RE: **Grants Reclamation Project – DP-200 Renewal – Response to September 12, 2000 NMED Letter Transmitting Comments / Questions on Renewal Application**

**HOMESTAKE MINING COMPANY
Grants Reclamation Project
DP-200 Renewal**

**RESPONSES TO
NEW MEXICO ENVIRONMENT DEPARTMENT
REGARDING QUESTIONS / COMMENTS ON DP-200
RENEWAL APPLICATION
PER
NMED LETTER DATED SEPTEMBER 12, 2000**

FIGURE 20. TDS CONCENTRATIONS FOR WELLS D1, X, S4, F, FB AND GH.

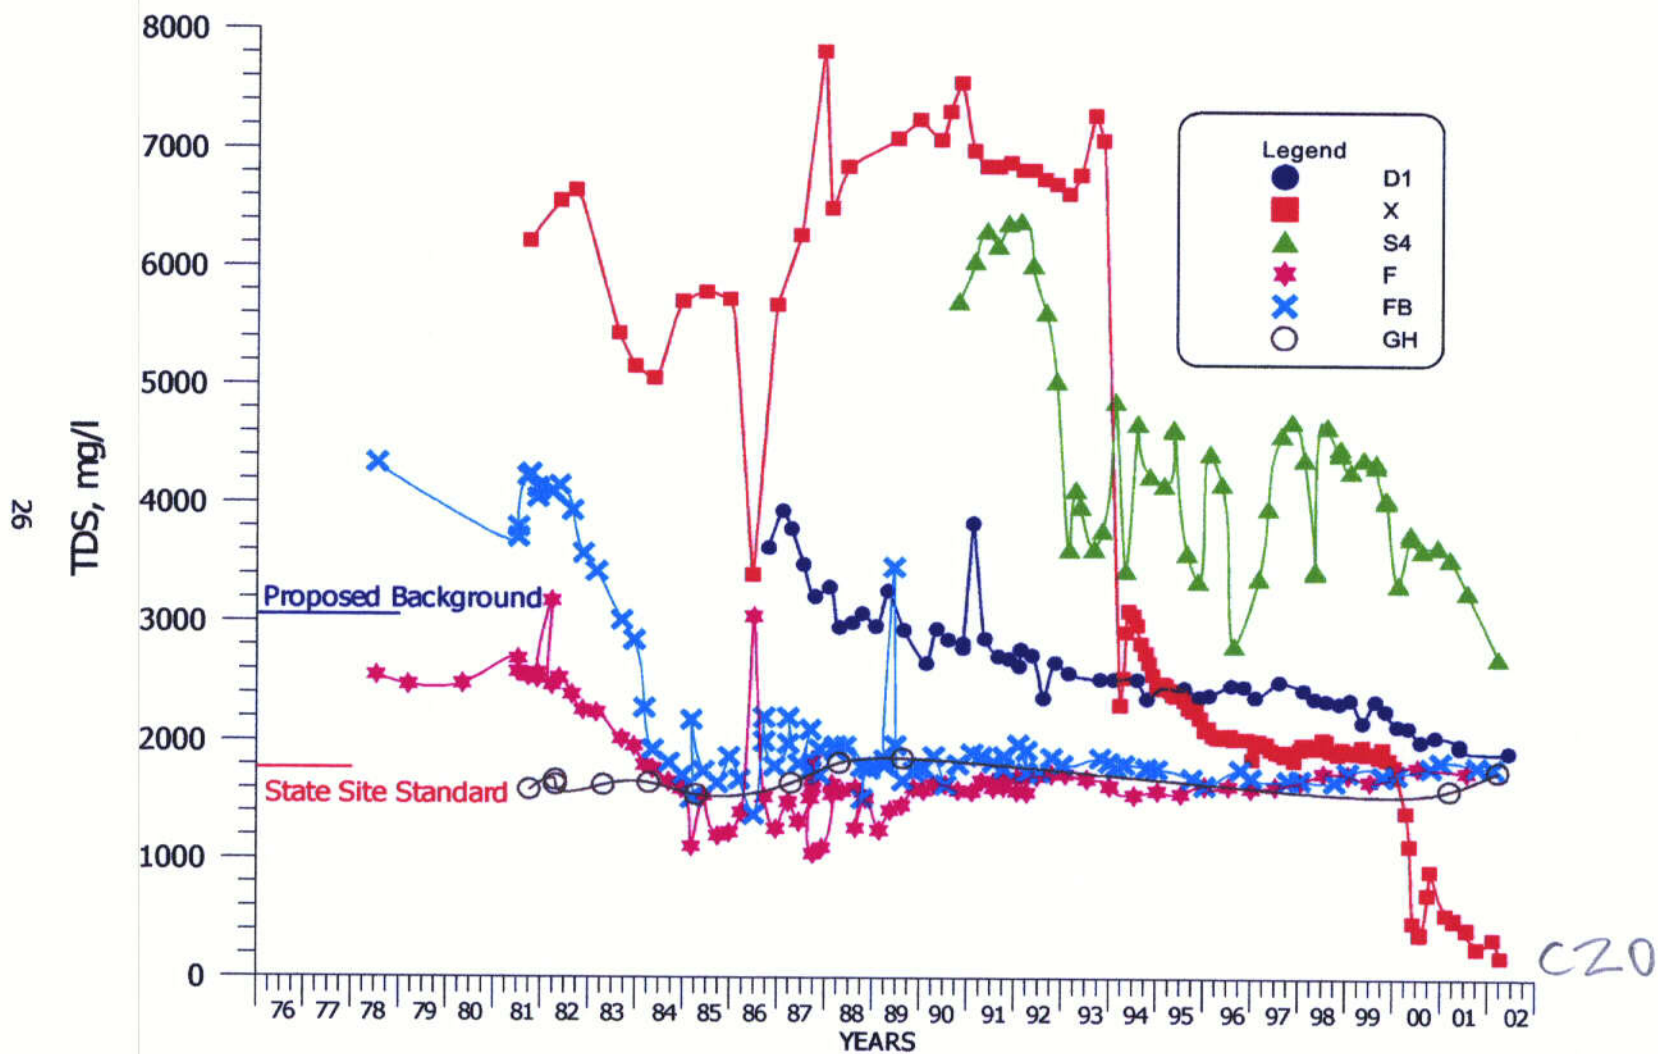
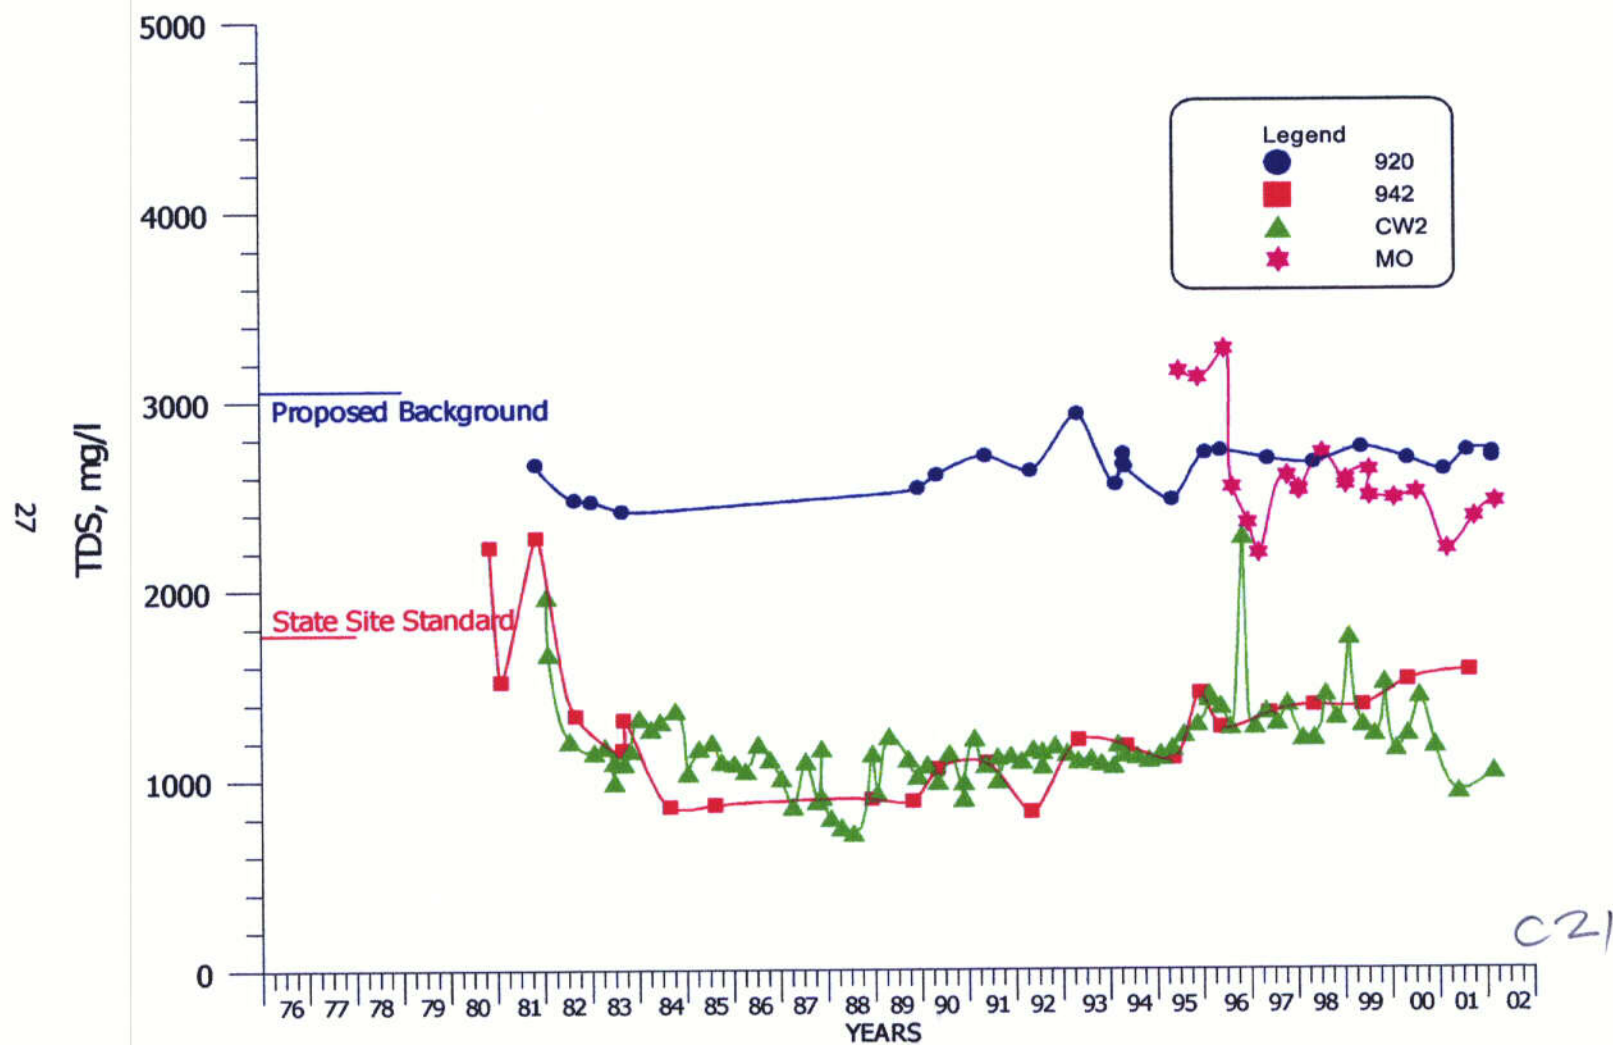
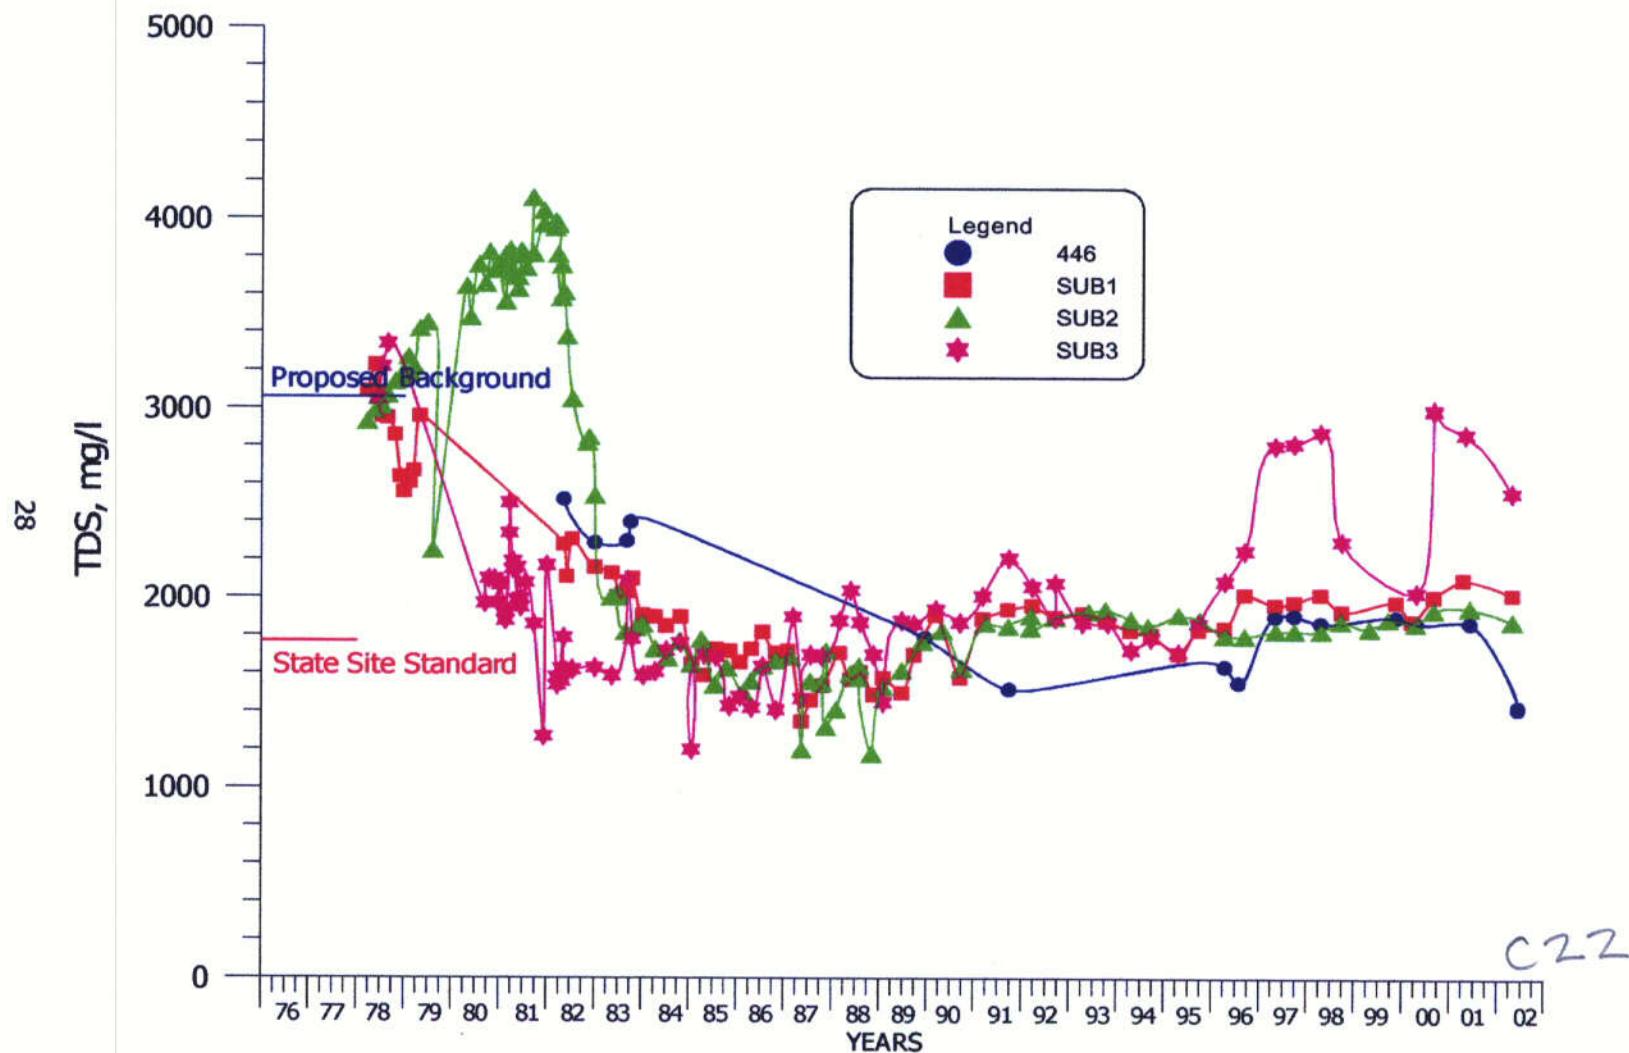
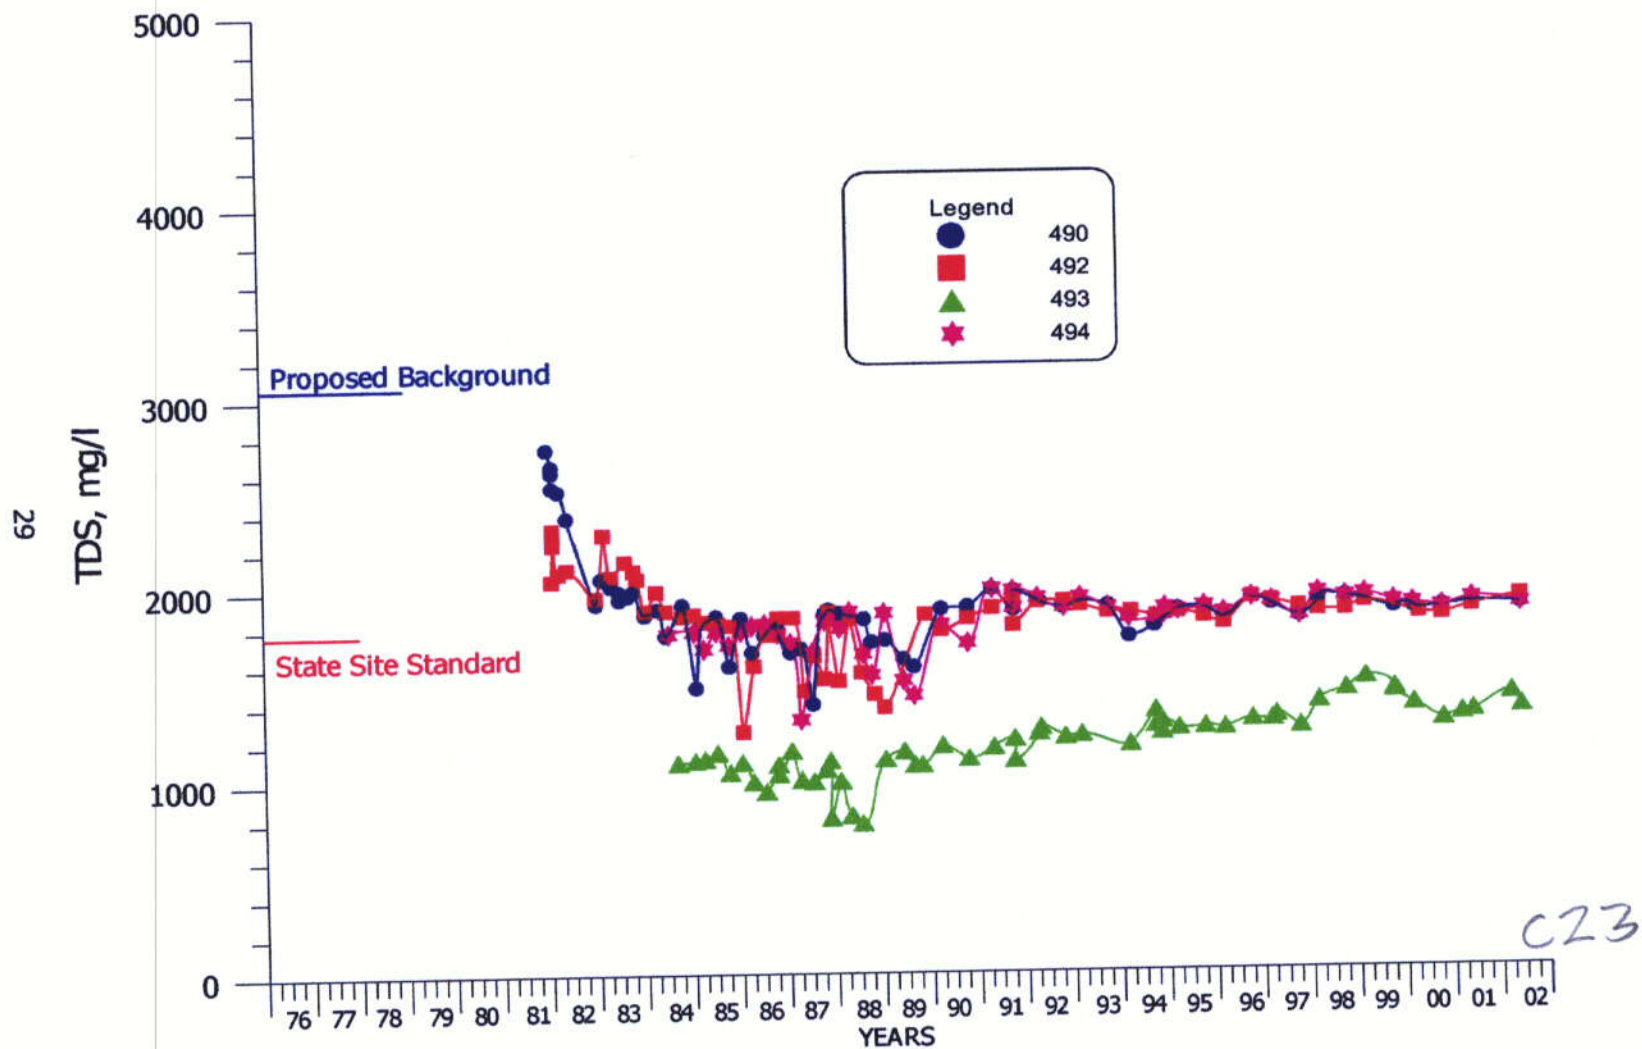
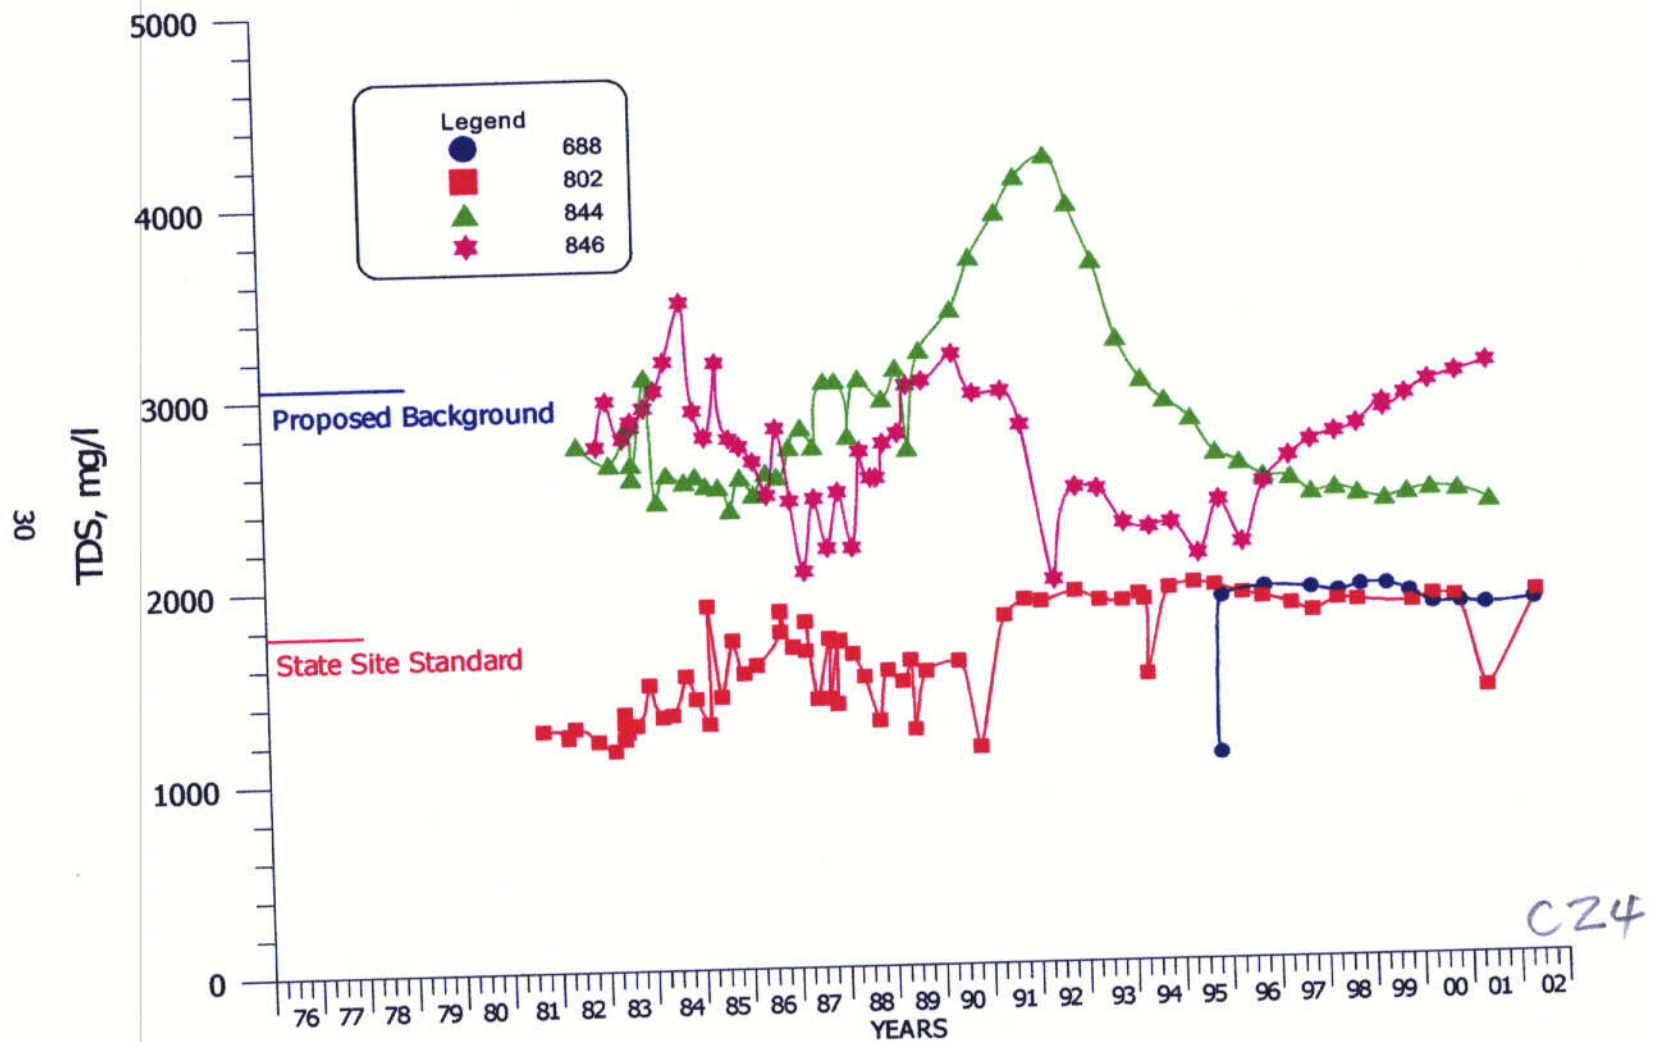
Comment: III.1.B. Graphs of Water-quality Data for the Table 2 Wells

Response: Plots for the routine monitoring wells from Table 2 of the NRC license are presented for sulfate, TDS, chloride, uranium, selenium, molybdenum and nitrate concentrations as Figures 15 through 49. The first group of wells for each of these constituents are presented for the three POC wells (Wells D1, X and S4) and

the initial figure also includes on site wells (Wells F, FB and GH). The following tabulation lists the figure numbers for each of the constituents:

CONSTITUENT	FIGURE NUMBER
SO4	15 – 19
TDS	20 – 24
Cl	25 – 29
U	30 – 34
Se	35 – 39
Mo	40 – 44
NO3	45 – 49

A few different vertical scales were required due to the large variations in parameter concentrations. The present State standard and the proposed background concentrations are presented on the plots.
